METROPOLITAN GOVERNMENT OF NASHVILLE AND DAVIDSON COUNTY

STAFF RECOMMENDATION 517 Acklen Park Drive April 17, 2013

Application: New construction—Primary building
District: Richland-West End Addition Neighborhood Conservation Zoning Overlay
Council District: 24
Map and Parcel Number: 10405043200
Applicant: Preston Quirk
Project Lead: Melissa Baldock, melissa.baldock@nashville.gov

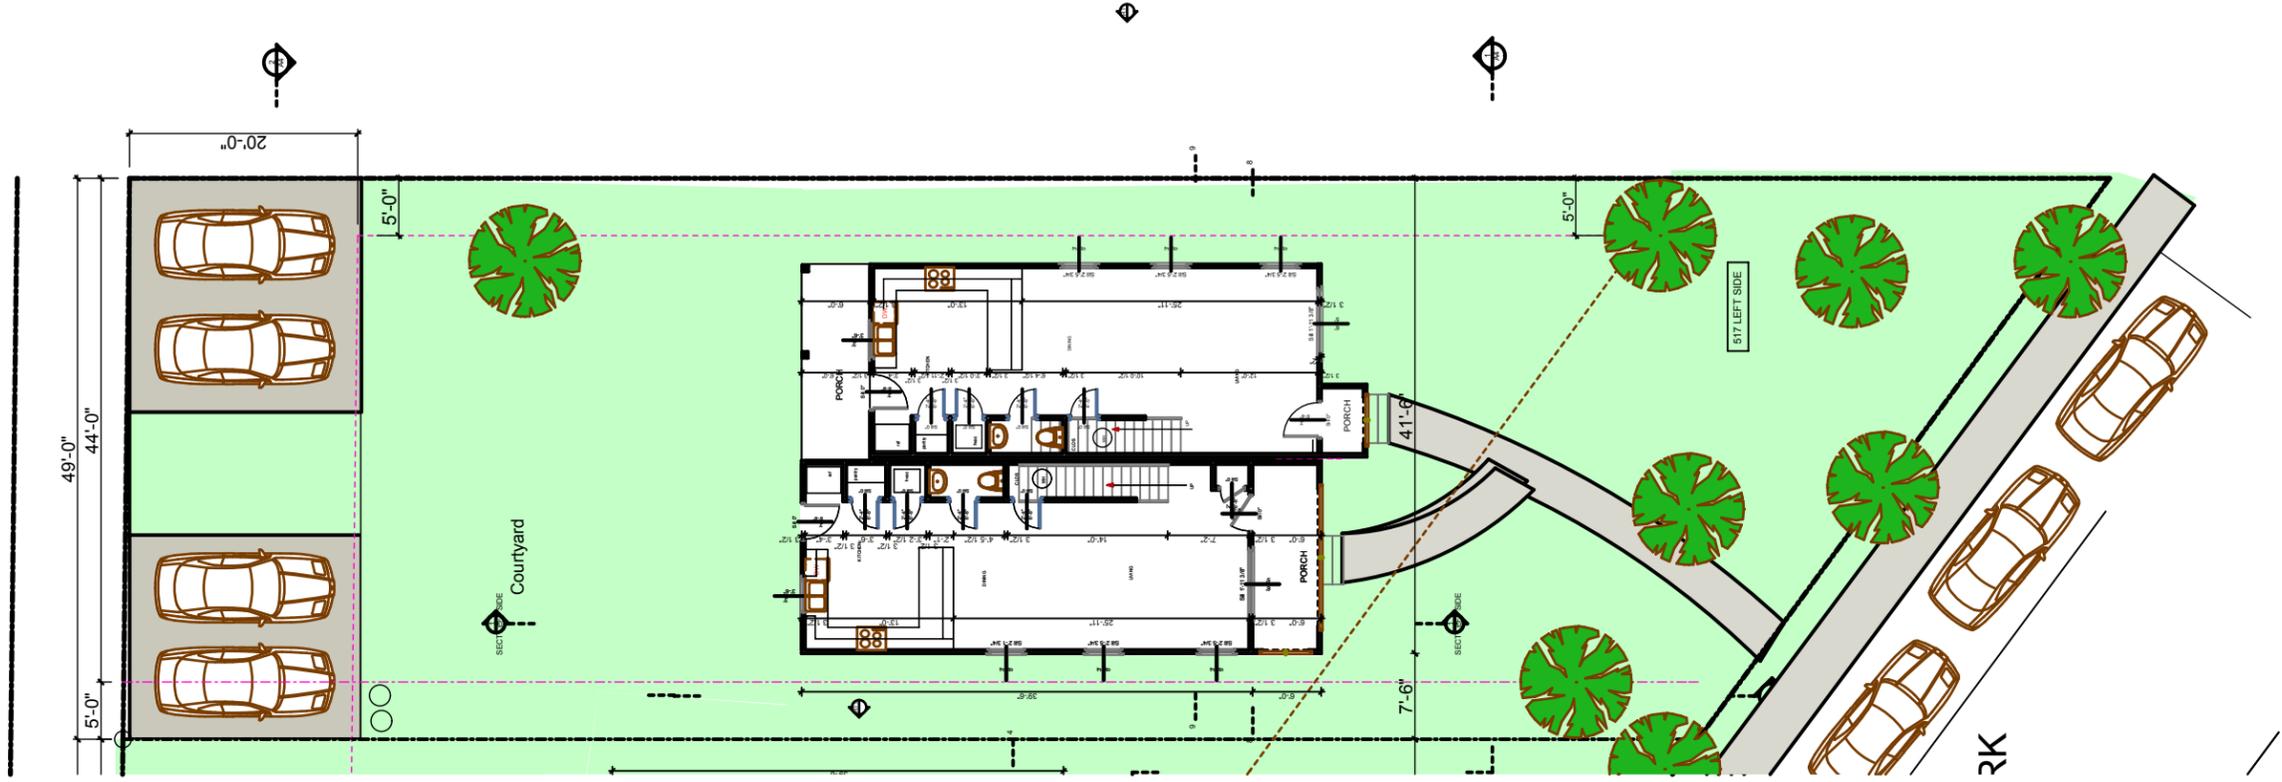
Proportion and Rhythm of Openings: The primary windows on the duplex are approximately twice as tall as they are wide, and so meet the historic ratio of windows. In addition, the windows on the upper stories are as tall or are shorter than the windows on the primary floor. The two side facades do contain a wall expanse of approximately sixteen feet (16') without a window or door opening. Staff finds this expanse to be appropriate because it occurs on the back half of the house and therefore will be less visible from the street. Staff asks that the applicant ensure that there are four to six inch (4" – 6") mullions in between the house's double windows. With this condition, staff finds that the window proportions and rhythm of openings meets Section II.B.1.g. of the *Richland-West End Addition Neighborhood Conservation Zoning Overlay Handbook and Design Guidelines*.

1 SITE PLAN

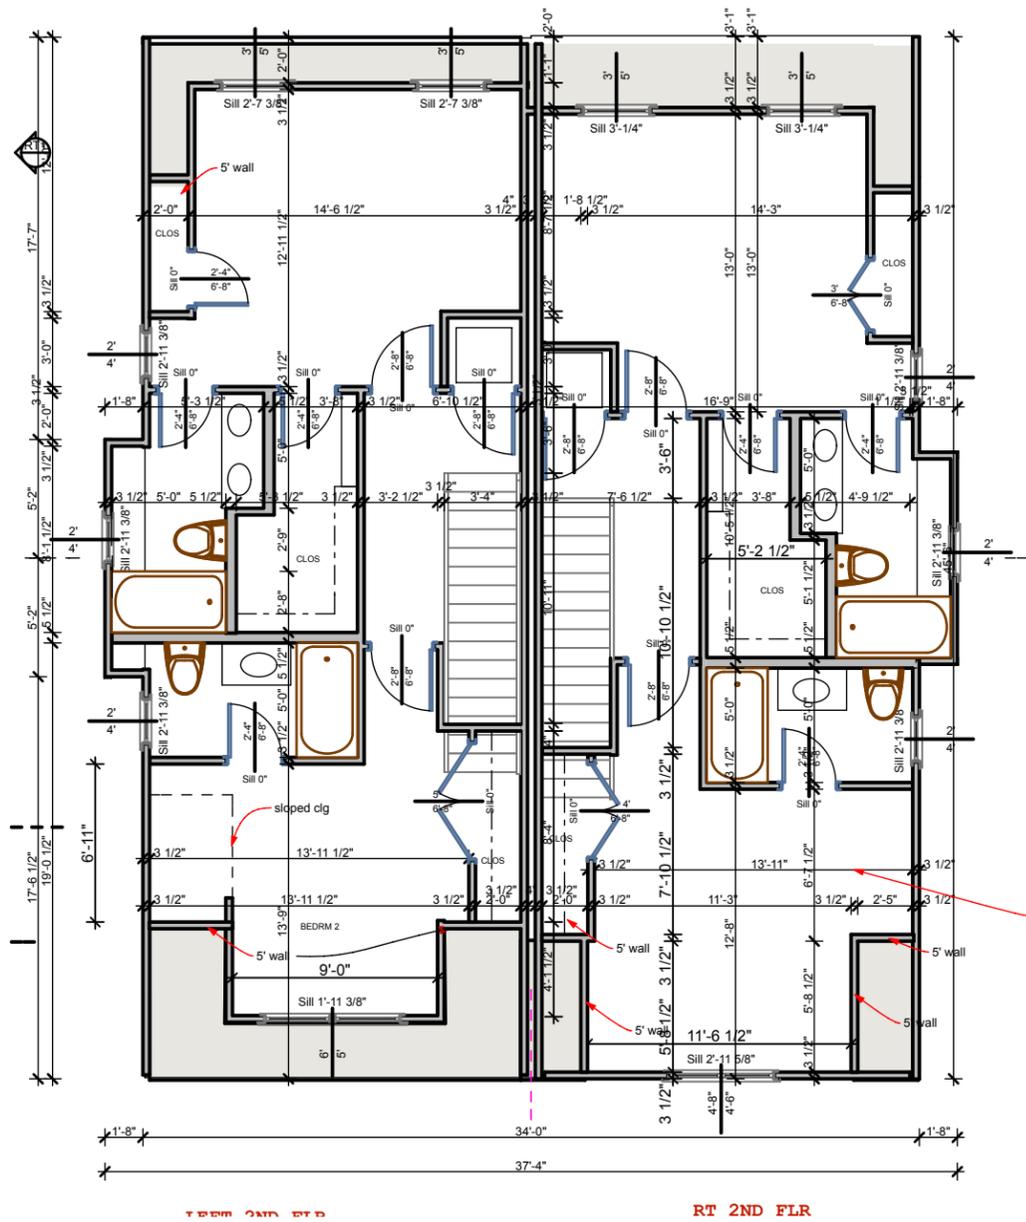
Location and Setback: The proposal meets all bulk zoning setback requirements. The lot for No. 515 is angled at the front, but the house will be situated to be parallel to the rear lot line, which is not angled. Because there is no historic context on this street, the front setback, which ranges from forty-eight feet (48') at its closest point to seventy-two feet (72') at its farthest point, is appropriate. The front setback will match that of the duplex at No. 515. The duplex will be centered on lot and will be approximately seven feet, six inches (7'6") from the right and the left side property lines. Staff finds that the duplex meets Sections II.B.1.c. and II.B.1.h. of the *Richland-West End Addition Neighborhood Conservation Zoning Overlay Handbook and Design Guidelines*.

Appurtenances: The site plans shows two double-width parking pads in the rear of the property, accessed from the alley, which is appropriate. No other appurtenances were indicated on the site plan, and staff asks to review and approve any other appurtenances before they are installed.
